RE: Review of File # Z25-371PPLT

After review of the above described application, it has been determined to be technically complete according to Spokane Municipal Code (SMC) 17G.061.120, Determination of a Complete Application.

DATE: September 3, 2025 / *Revised 9/8/2025*
TO: Melissa Owen, Assistant Planner
FROM: Joeline Eliason, Engineering Technician IV – Development Services
THROUGH: Eldon Brown, P.E., Principal Engineer – Development Services
File No: Z25-371PPLT
SUBJECT: Latah Glen Residential Preliminary Plat – 3rd Review (*REVISED*)

From sewer drawing.

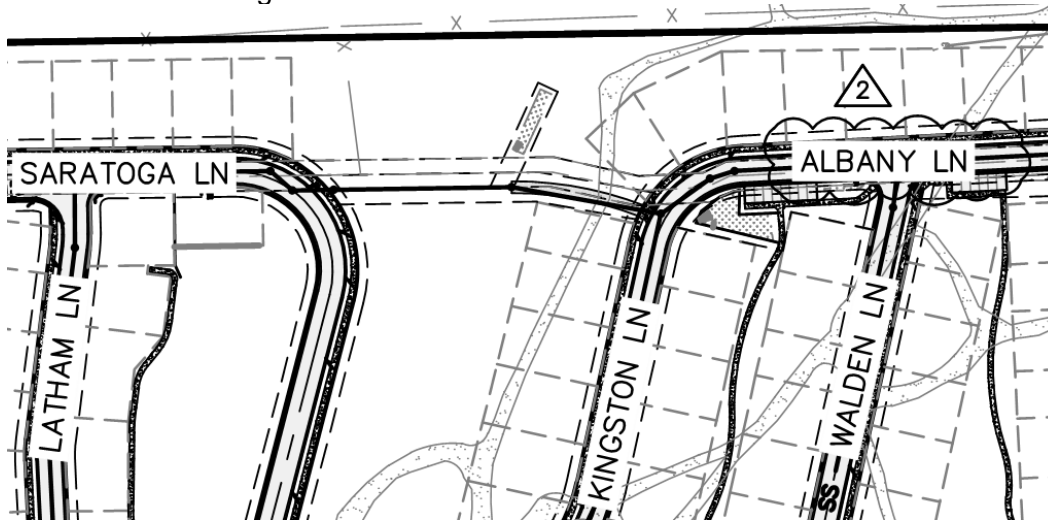
- A. It appears they have left off the utility easement for both water and sewer in parallel from Saratoga to Albany. Easement will need to be 30' wide, not 16' wide, and should be within a utility tract for boundary definition. (M. Owen Note: A new separate easement will need to be recorded and documented on the plat map prior to final plat approval per M. Owen Conversations with Eldon Brown.)

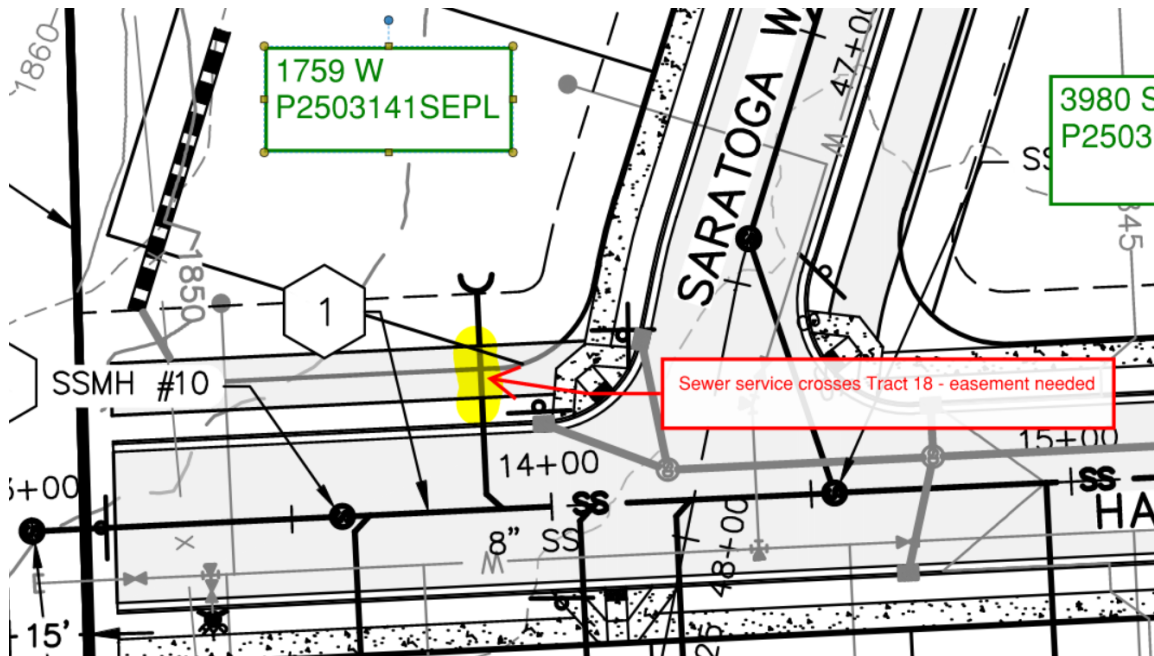
1. The "PATH EASEMENT" on Lot 3 Block 16 should be better defined *or the lot line moved to not include the path.*

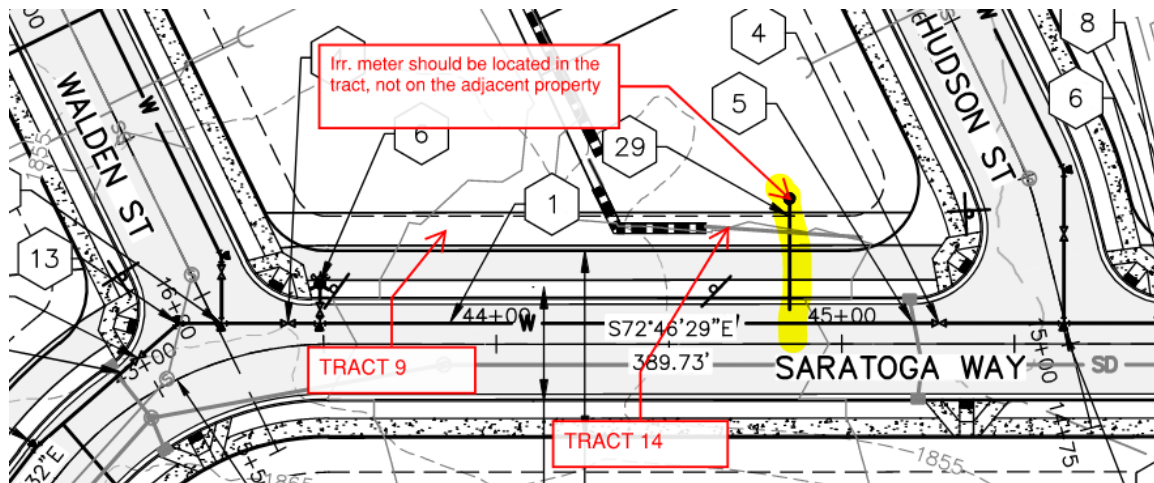
2. A sewer easement will be required for the proposed sewer connection to Lot 3 Block 16 (see snip below from construction plans).

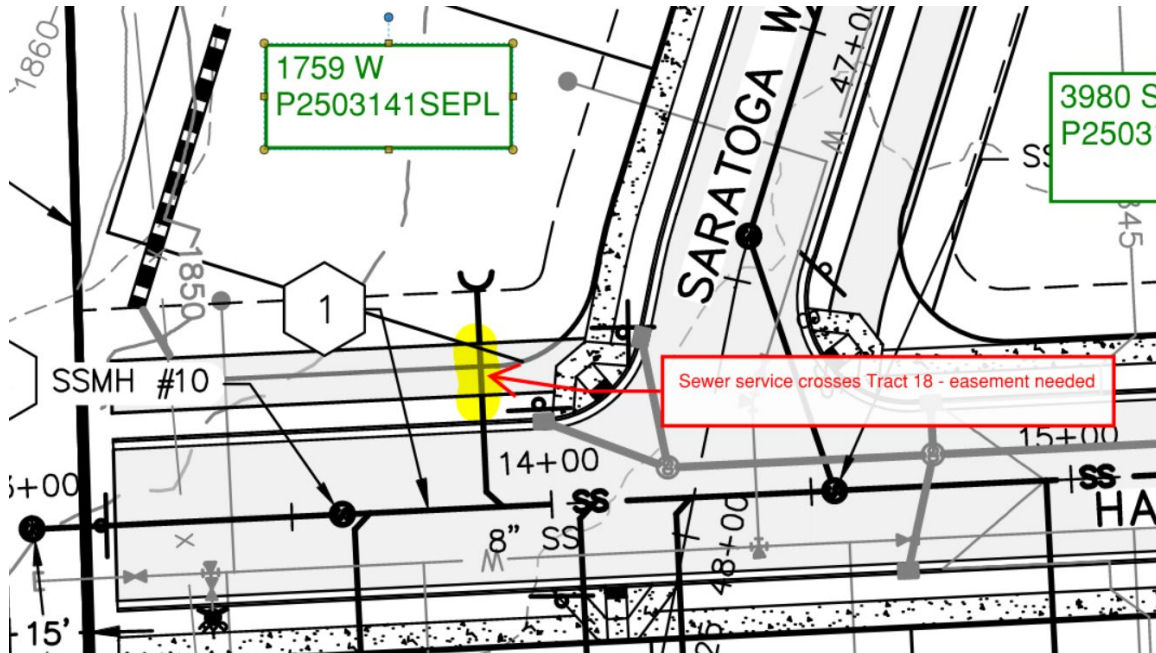
2. A sewer easement will be required for the proposed sewer connection to Lot 3 Block 16 (see snip below from construction plans).

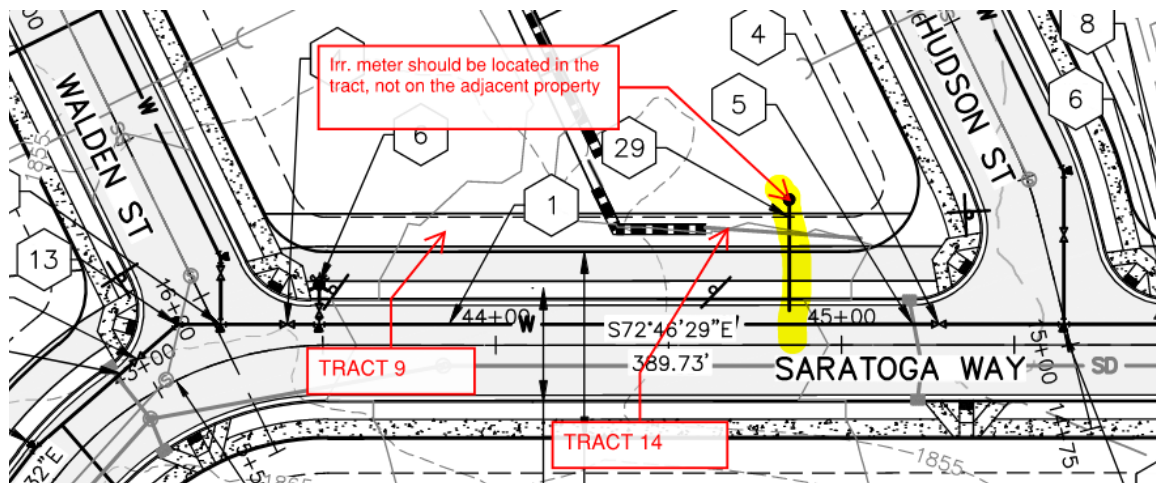
3. Is it intended for Tract 9 and Tract 14 to share an irrigation meter (see snip below)?

From sewer drawing.

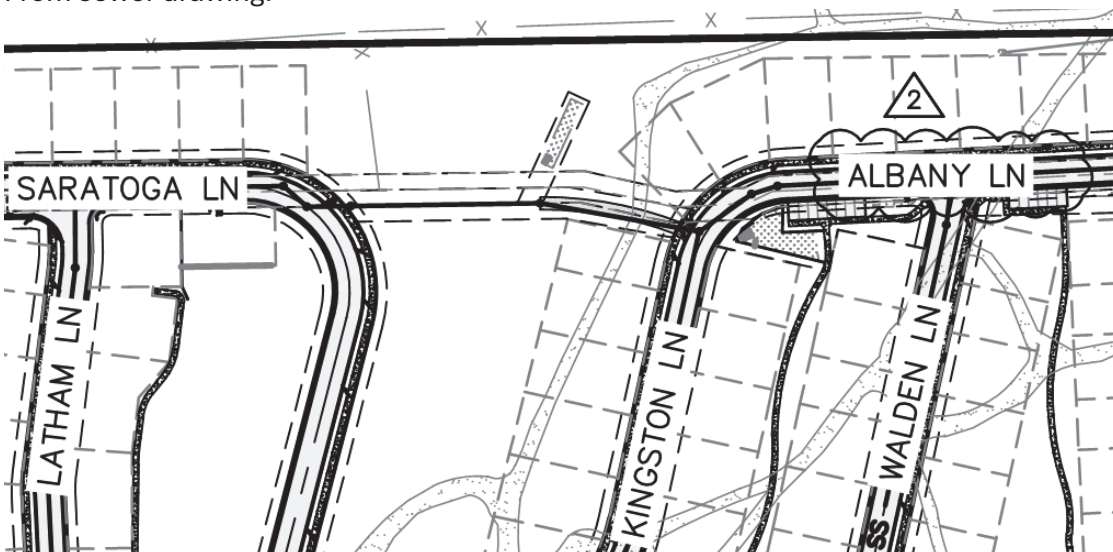
It appears they have left off the utility easement for both water and sewer in parallel from Saratoga to Albany. Easement will need to be 30' wide, not 16' wide, and should be within a utility tract for boundary definition.
